<b>Title - Sujet</b> Picnic Tables, Fundy National Park Picnic Tables, Fundy National Park	
<b>Solicitation No. - N° de l'invitation</b> 5P132-200375/A	<b>Amendment No. - N° modif.</b> 001
<b>Client Reference No. - N° de référence du client</b> 5P132-200375	<b>Date</b> 2020-11-30
<b>GETS Reference No. - N° de référence de SEAG</b> PW-\$MCT-042-5837	
<b>File No. - N° de dossier</b> MCT-0-43067 (042)	<b>CCC No./N° CCC - FMS No./N° VME</b>
<b>Solicitation Closes - L'invitation prend fin</b> <b>at - à 02:00 PM</b> Atlantic Standard Time AST <b>on - le 2020-12-15</b> Heure Normale de l'Atlantique HNA	
<b>F.O.B. - F.A.B.</b> <b>Plant-Usine:</b> <input type="checkbox"/> <b>Destination:</b> <input checked="" type="checkbox"/> <b>Other-Autre:</b> <input type="checkbox"/>	
<b>Address Enquiries to: - Adresser toutes questions à:</b> Stockman (MCT), Sonia	<b>Buyer Id - Id de l'acheteur</b> mct042
<b>Telephone No. - N° de téléphone</b> (506) 961-7412 ( )	<b>FAX No. - N° de FAX</b> (506) 851-6759

## Solicitation Amendment

### Picnic Tables, Fundy National Park

Solicitation Amendment No. **001**

*\*the above picture is for dimensional reference only, not intended as a design*

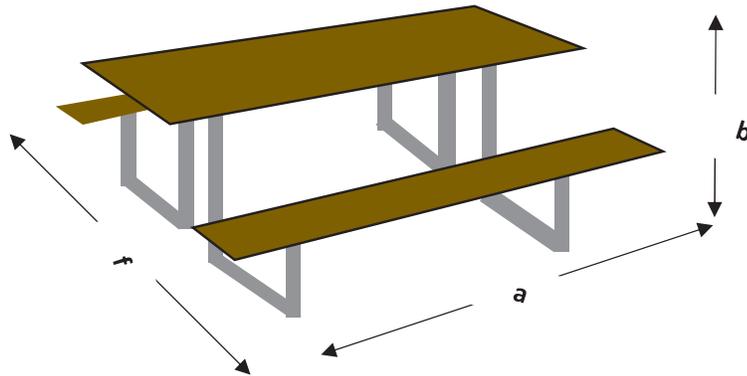
Q2. Can a photo or a specification sheet be provided of the best-suited picnic table design determined by Fundy National Park by piloting multiple versions over the past several years?

A2. **This statement of requirement reflects the best suited specification. The frame set-up preferred matches the dimension image provided, however if an alternate frame set-up meets all requirements it would still be acceptable.**
